LiDAR Quality Assessment Report

UT_GSLMiddle_2011

This data set created using LiDAR points collected from airborne surveys completed between October 10, 2011 and October 12, 2011 and covers approximately 83 square miles contained in the following county(s): Weber County, Utah; Davis County, Utah.

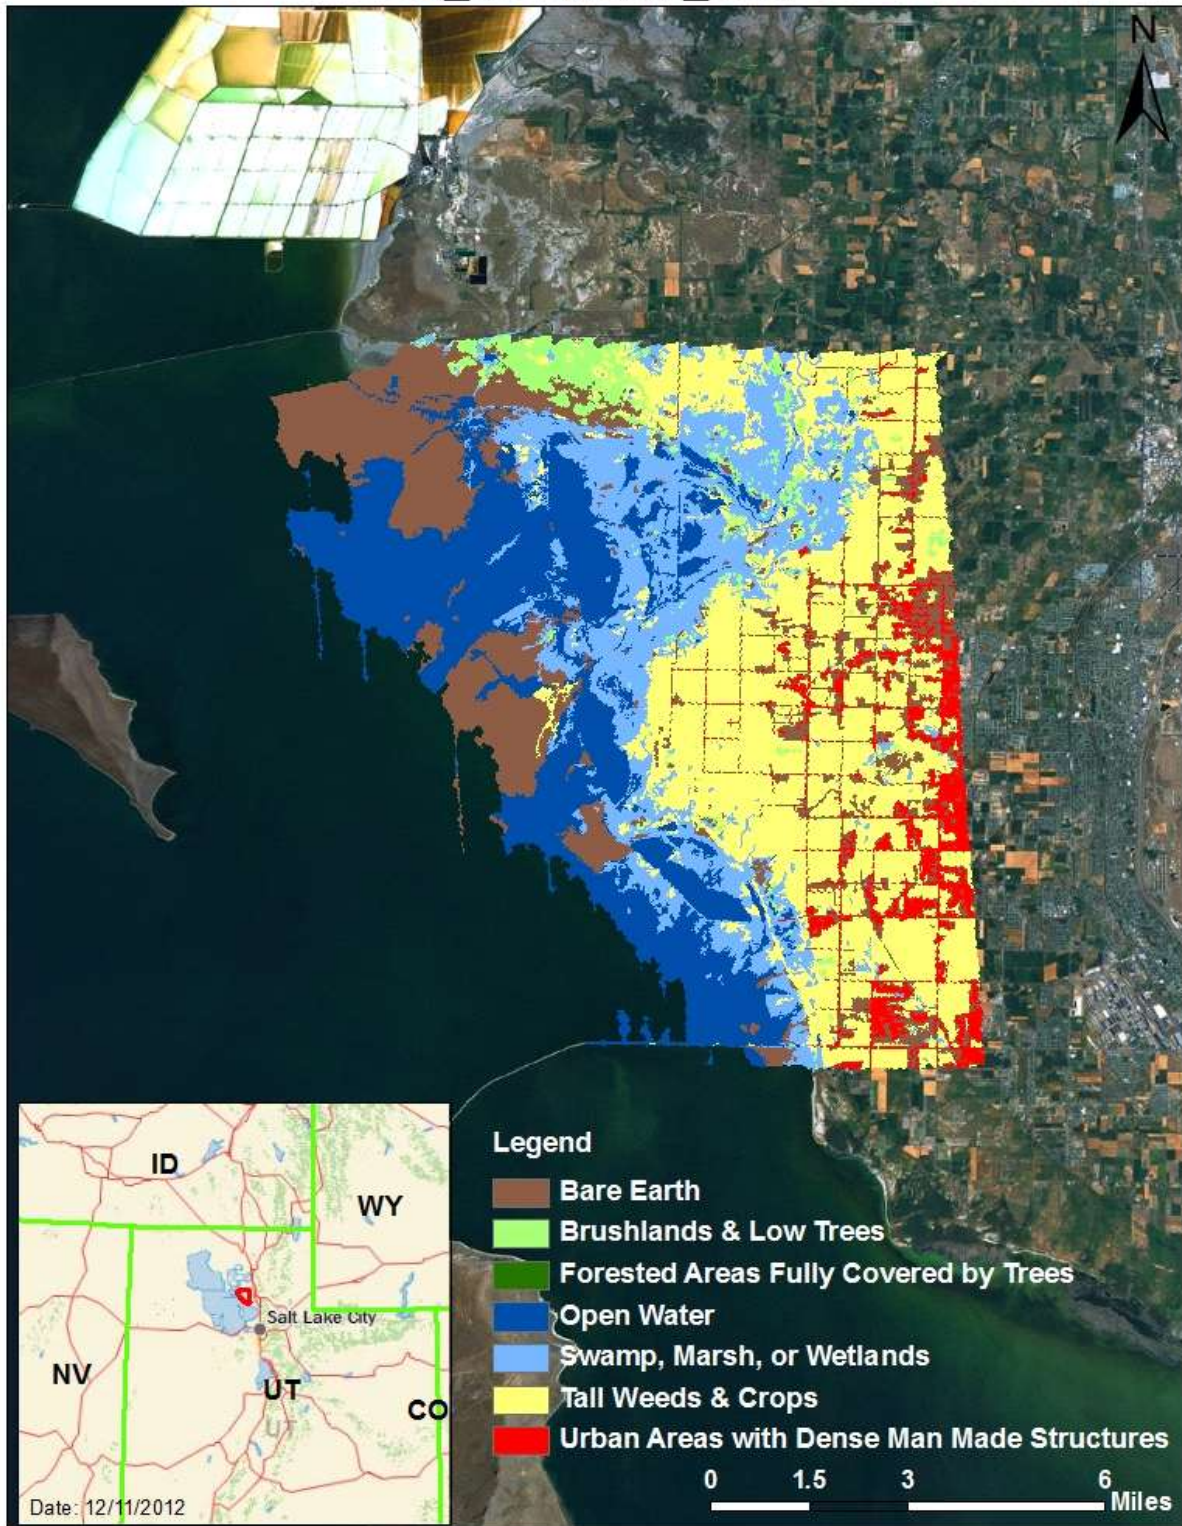
There are a minimum of 20 checkpoints for each land cover class represented. Points

within each class are uniformly distributed throughout the dataset. USGS was notable to locate independent checkpoints for this analysis. USGS does not accept at this time the quality of the checkpoint data for these LiDAR datasets.

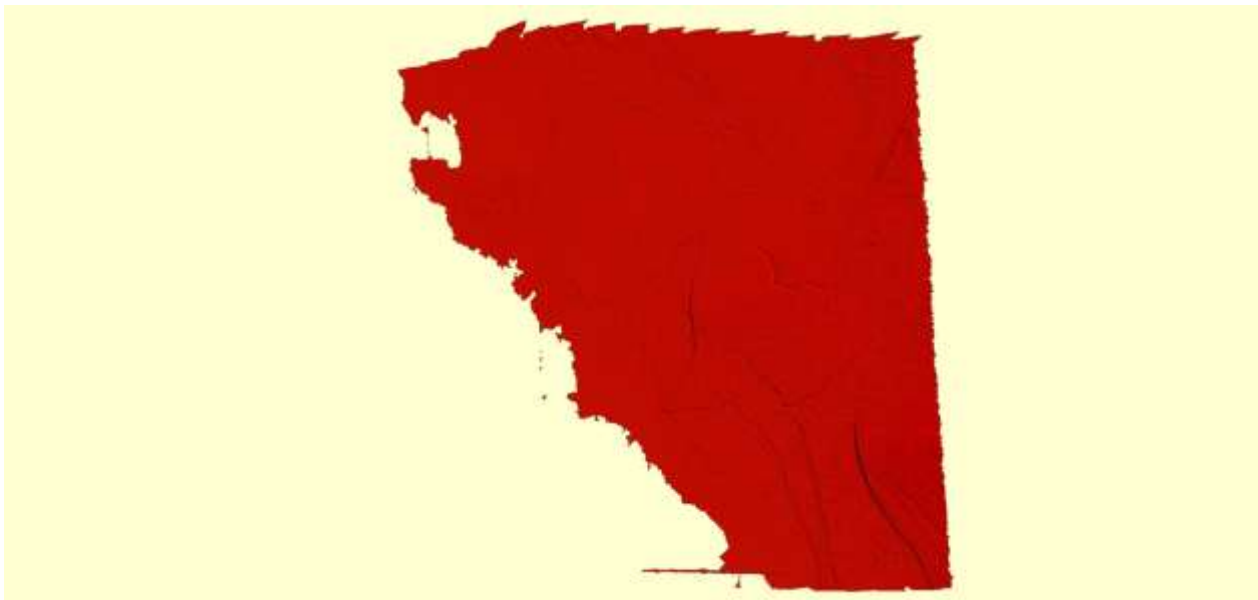
Vertical Accuracy was not assessed in the Traditional Manner for this Project, for more information see the [GSL_CompletionReport](#). It is reported that:
There is a tested < 4 cm RMSEz relative accuracy,
There is a tested < 7 cm RMSEz overlap accuracy, and
There is a tested < 8 cm RMSEz fundamental vertical accuracy.
The Metadata contains the following statement in regards to Vertical Accuracy:
"Quality control and assurance procedures have been completed and there are known discrepancies between local benchmark control elevations and LiDAR elevations. If this LiDAR data is to be adapted for local use with a local datum, it is strongly recommended that the services of a professional surveyor be obtained in order to make custom adjustments to the data".
